#PIT5542: Front Seat Lateral Movement and/or Unable To Install Front Seat Lateral Retainer When Performing PI1376 Or PI1183 - (Jan 25, 2017)

Subject: Front Seat Lateral Movement and/or Unable To Install Front Seat Lateral Retainer When Performing PI1376 Or PI1183

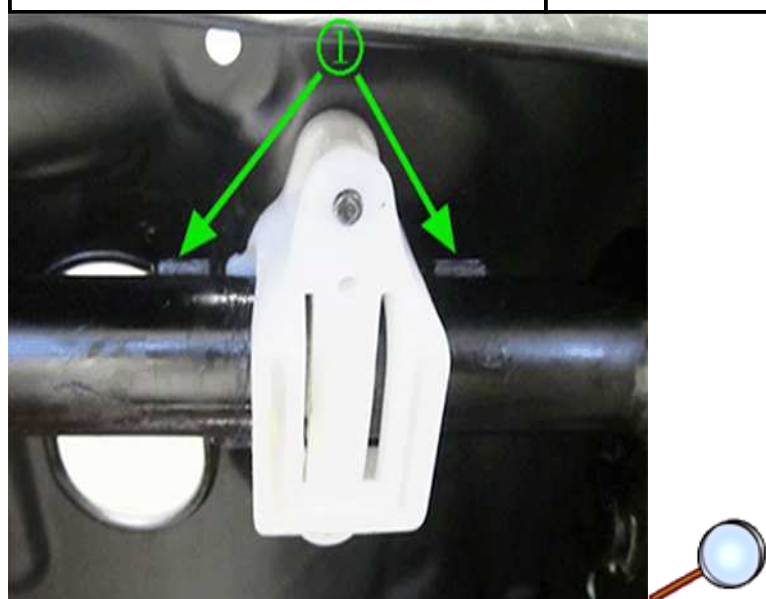
Involved Region or Country	North America and N.A. Export Regions
Additional RPO/s:	N/A
Condition	Some customers may comment of excessive lateral driver or passenger seat movement and/or a clunk/click/pop type feeling or noise. This condition occurs when the seat is occupied and the vehicle is being driven on roads with curves, or during low speed turning maneuvers.
Cause	<p>This concern could be caused by movement between the seat pan front pivot points and the seat frame pivot bar.</p> <p>For 2014 and 2015 Model years, a front seat lateral retainer was developed to correct lateral seat movement, as outlined in PI1376 and PI1183. If the seat frame base was previously replaced for any reason, the new seat frame would have the 2016/2017 updates, which incorporates the welded brackets as described below (1).</p> <p>For 2016 and 2017 model years, an updated seat frame design that incorporates welded brackets (1) to the seat frame pivot bar on each side of the white guide block. This helps to reduce the excessive lateral seat movement.</p> <p>Regardless of the model year, in some cases, even with the updated seat frame design, there still could be excessive clearance between the welded brackets (1) and the white guide block. This will cause excessive lateral seat movement.</p>

If excessive lateral seat movement is found between the welded brackets (1) and the white guide block, the front seat lateral retainer (GM PN 13405675) can be installed to correct this condition.

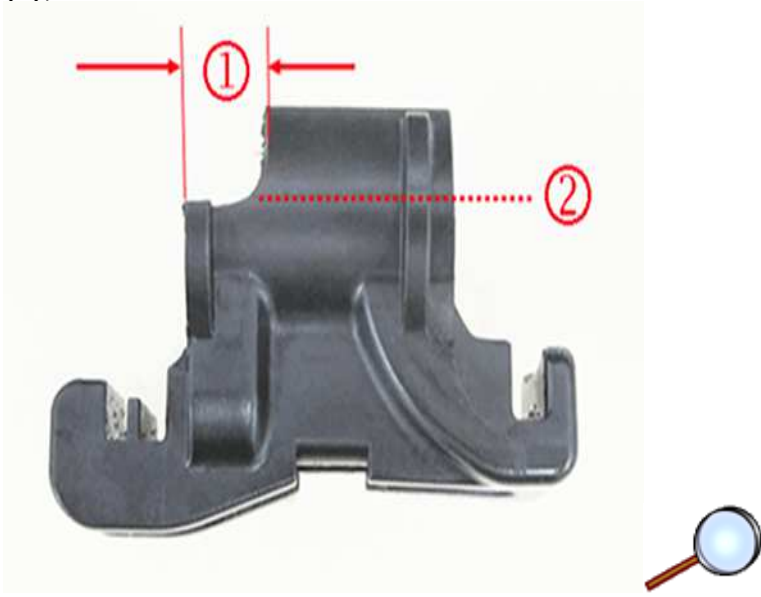
1. It will be necessary to remove plastic material from the top side of the guide end of the lateral retainer to enable installation. Using a grinder, or similar tool, remove approximately 10 mm (0.40 in) of material (1) from the top, down to the mold seam line

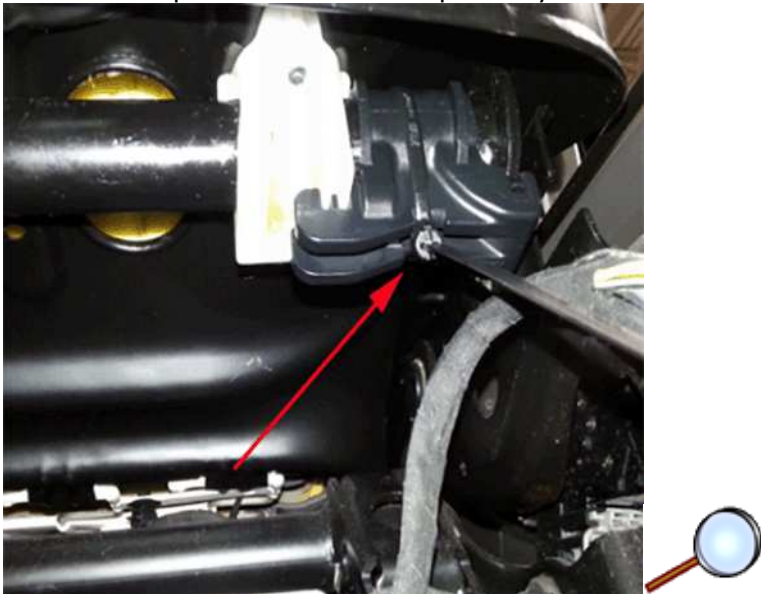
(2), shown below.

2. Install the clip and ensure the clip is fully seated around the pivot bar and on the guide block, as shown below.
